SERVICE BULLETIN

No. 509

Piper Aircraft Corporation

Replacement of Engine Mount Assembly
Attachment Nuts.

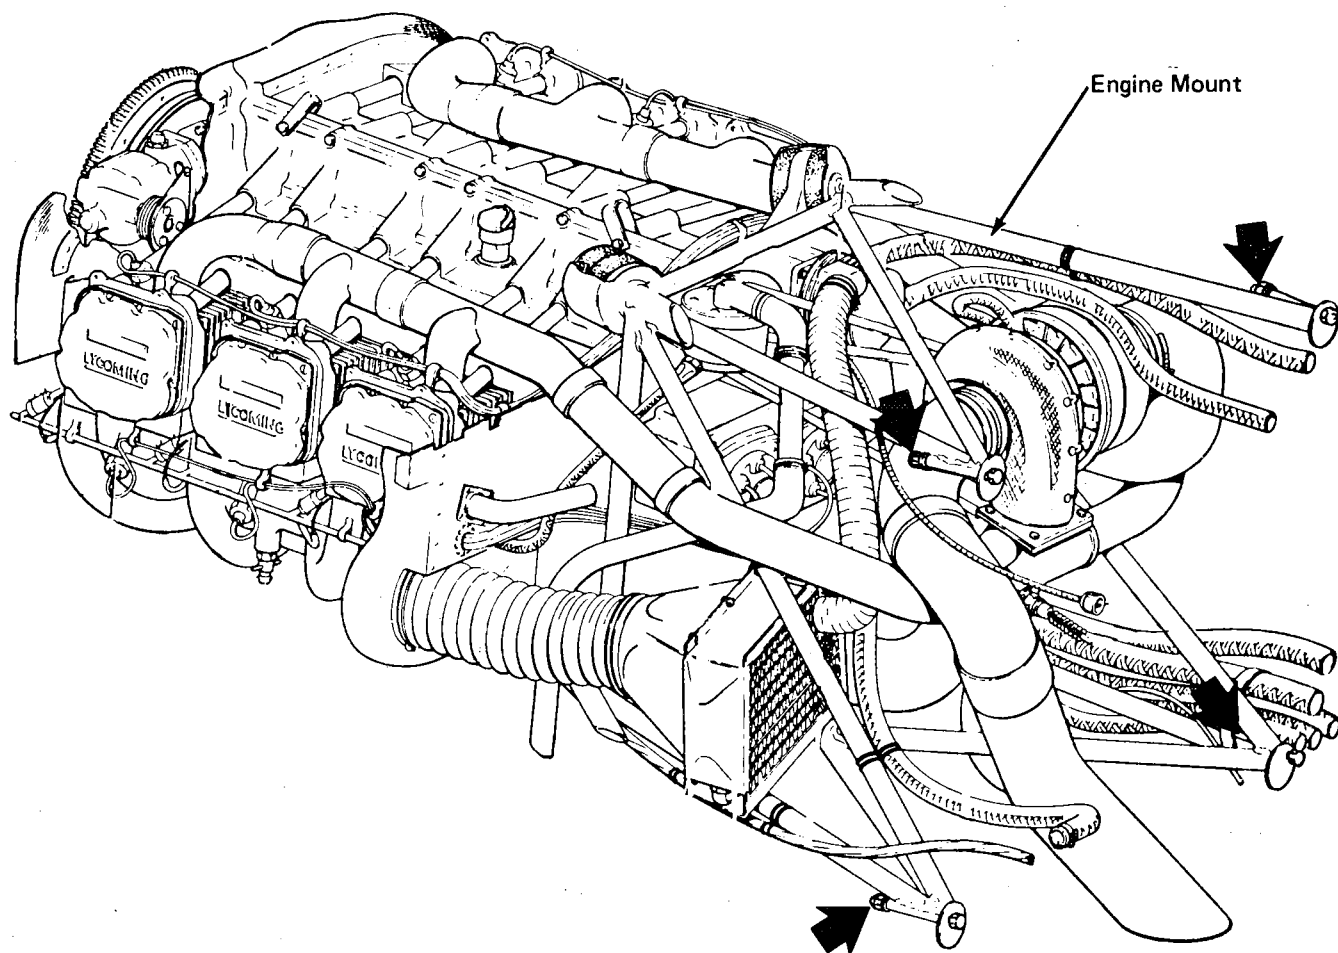
It has been determined that aircraft in the above specified group may have had engine mount assembly attachment nuts installed which were not cadmium-plated. This condition could eventually lead to corrosion of the nuts.

Refer to sketch/instruction sheet provided with this service release for location and proper installation of engine mount assembly attachment nuts.

Replace existing nuts on engine mount attachment bolts (four per mount) with new cad. plated nuts MS20365-624C (Piper P/N 404 890). Torque nuts to 160 to 190 inch-pounds (13 to 16 foot-pounds).
